Tslm  
Packet inputs

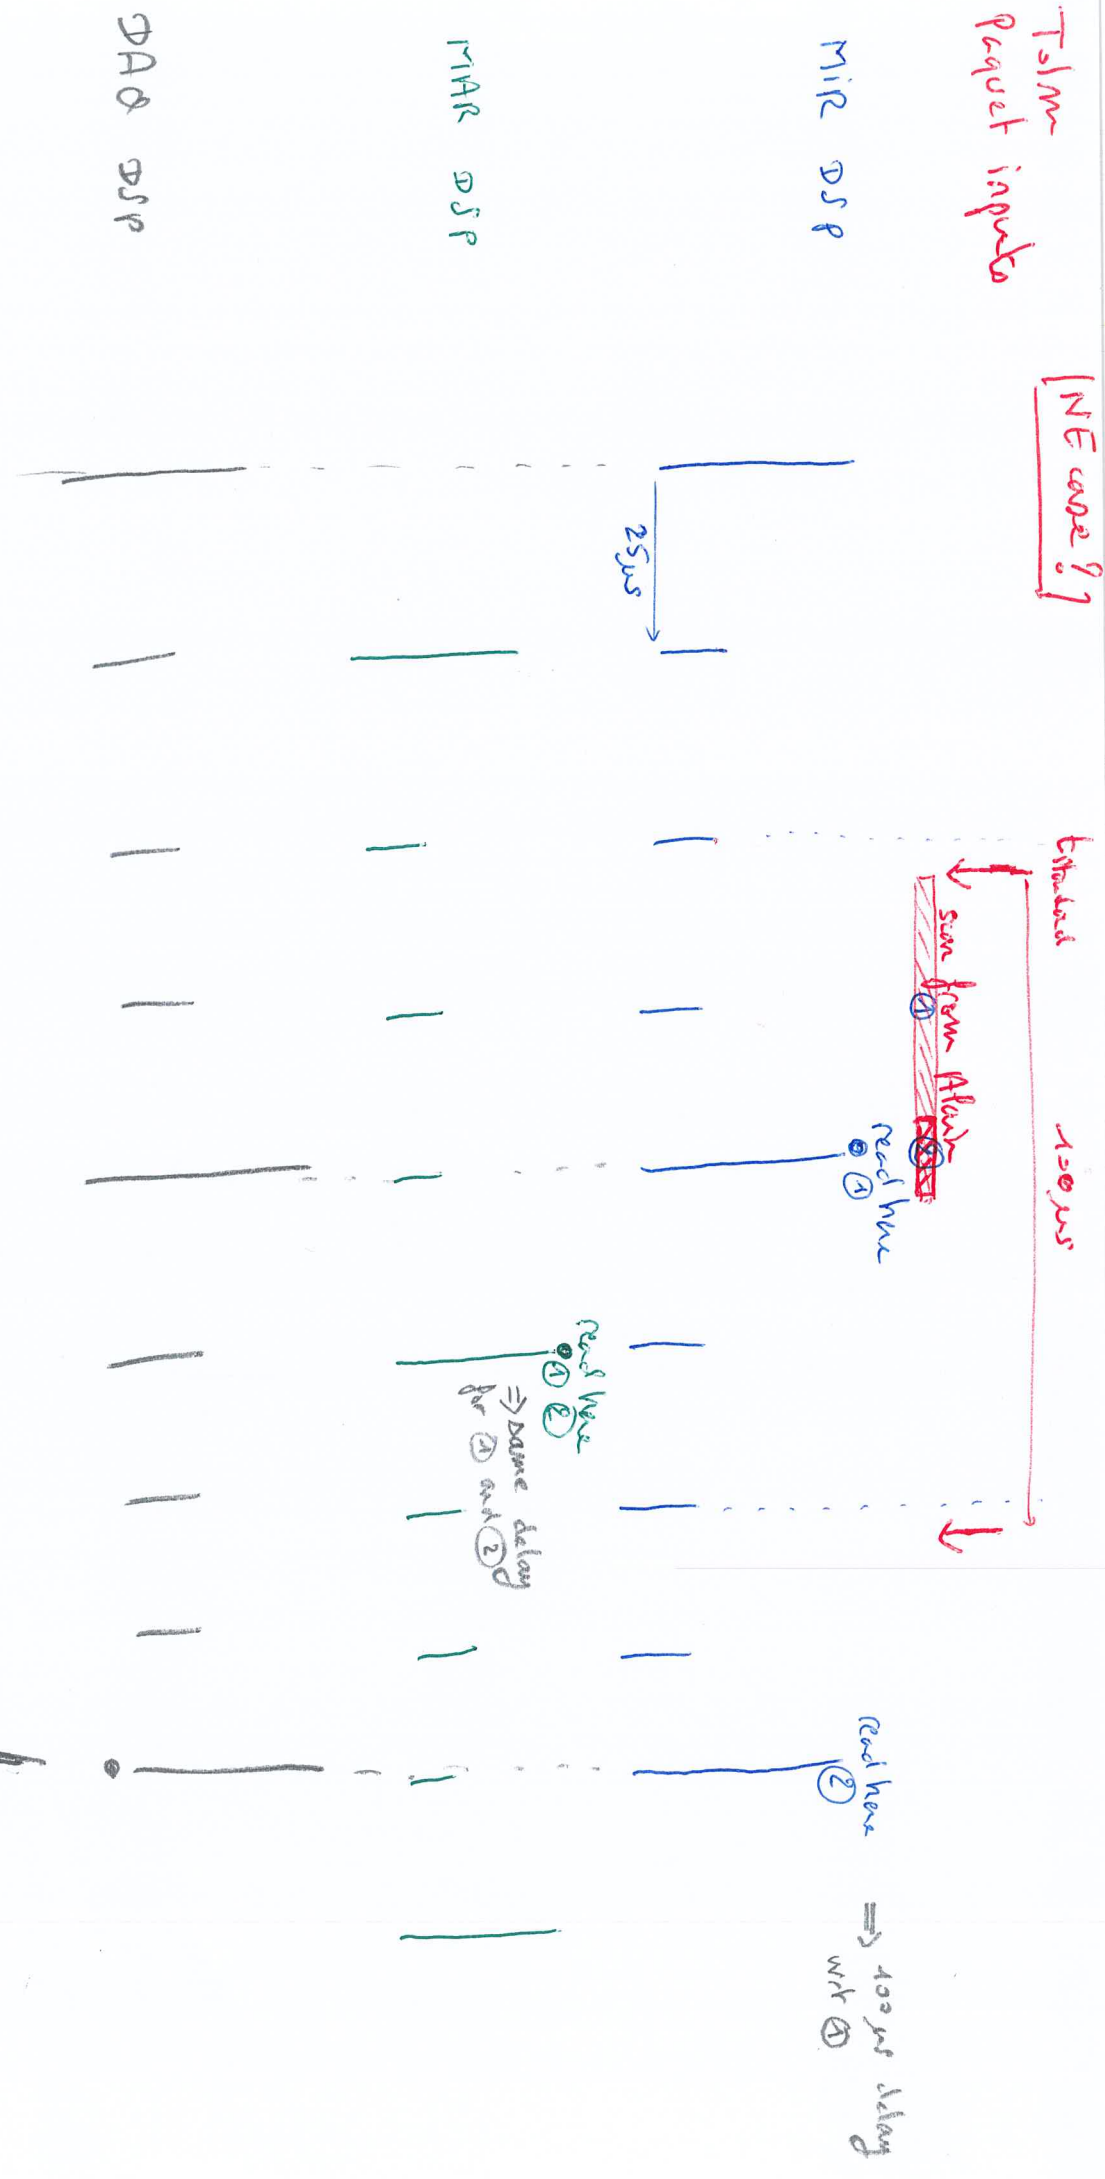
[NE code?]

→ Packets read every 100µs in the DSP (not every 25µs)

→ CAL to SC delay increased by (70-100µs) at the transition between ① and ② for T1AR

→ CAL to SC delay for T1AR did not change. (may try to scan 25µs more in the communication from RTIC to DSP)
